**FINAL SITE SPECIFIC/GENERIC ENVIRONMENTAL IMPACT  
STATEMENT  
FEIS**

**Proposed Action:  
City of Rochester Port Public Marina and Mixed Use Development Project**

**Date of Acceptance;  
March 2, 2012**

Exhibit 8  
Port Marina Project  
Phase I Marina  
and Public Improvements

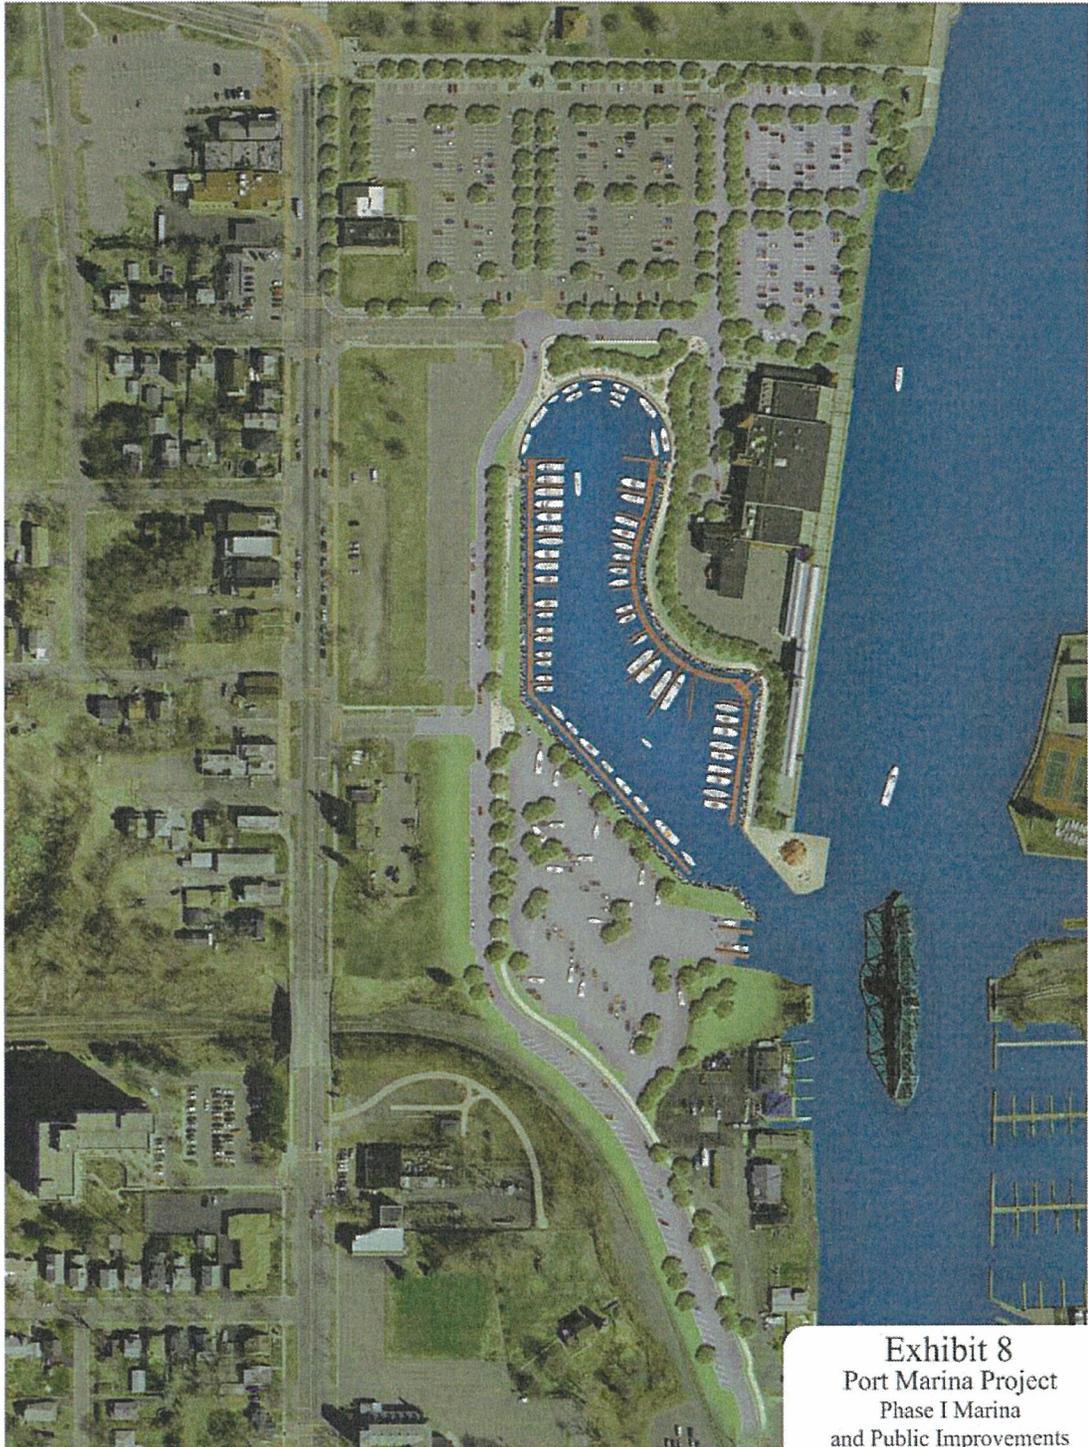
Comment: Exhibits 7 & 8 (pp39-40): The sheet pile proposed at the south side of the new marina entrance may encroach upon the north boat launch. The potential impacts are evident in Exhibit 7 (page #39) and the graphic attached to the City's September 30, 2011 response to the Departments Notice of Incomplete Application, yet Exhibit 8 does not show any encroachment. This inconsistency should be addressed and the design should not significantly encroach upon the northern launch area during the construction of phase I of the marina.

**RESPONSE: The inconsistency has been addressed and Exhibit 7 has been updated to reflect the marina entrance sheet pile design. The marina entrance design will not encroach upon the boat launch. Refer to FEIS Section III.**

Exhibit 14

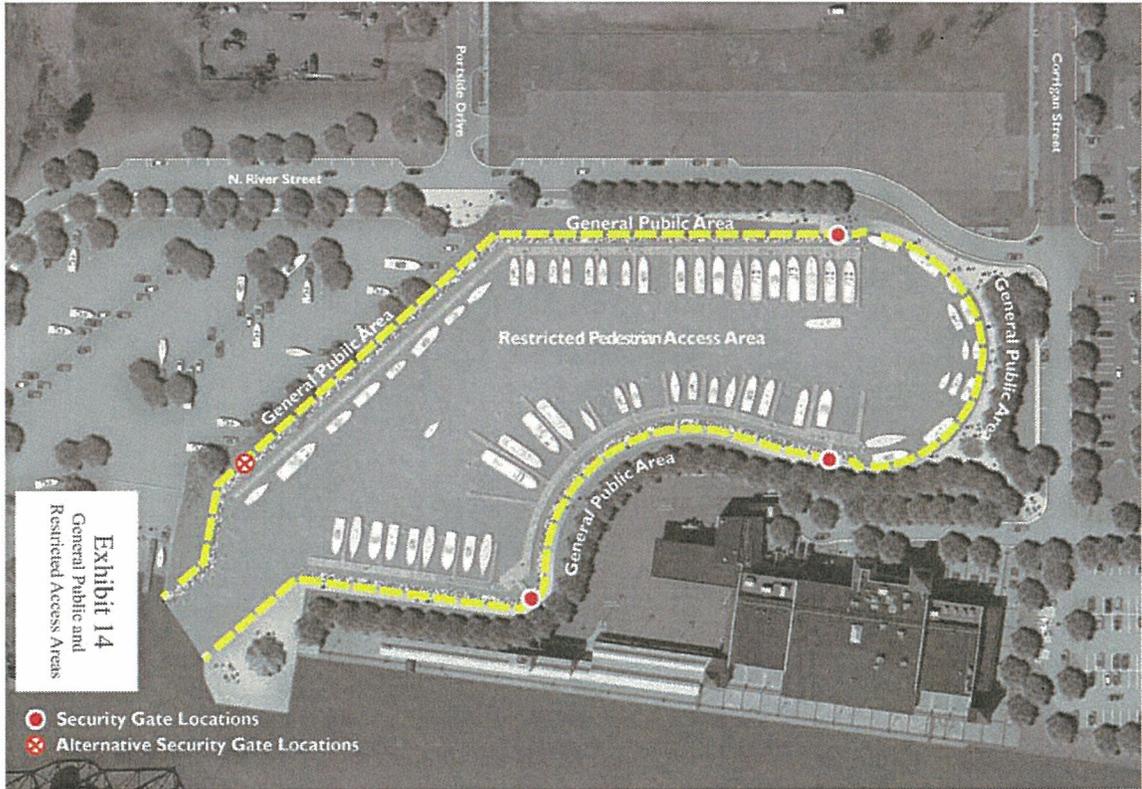
Section IV. Parks Recreation and Open Space - Exhibit 14 was created to define the general public and restricted pedestrian access areas within the marina. The floating docks and gangways will be restricted pedestrian access areas, secured by gates.

**RESPONSE: An Exhibit 14 was created to define the general public and restricted pedestrian access areas within the marina. The floating docks and gangways will be restricted pedestrian access areas, secured by gates. Refer to FEIS Section III.**
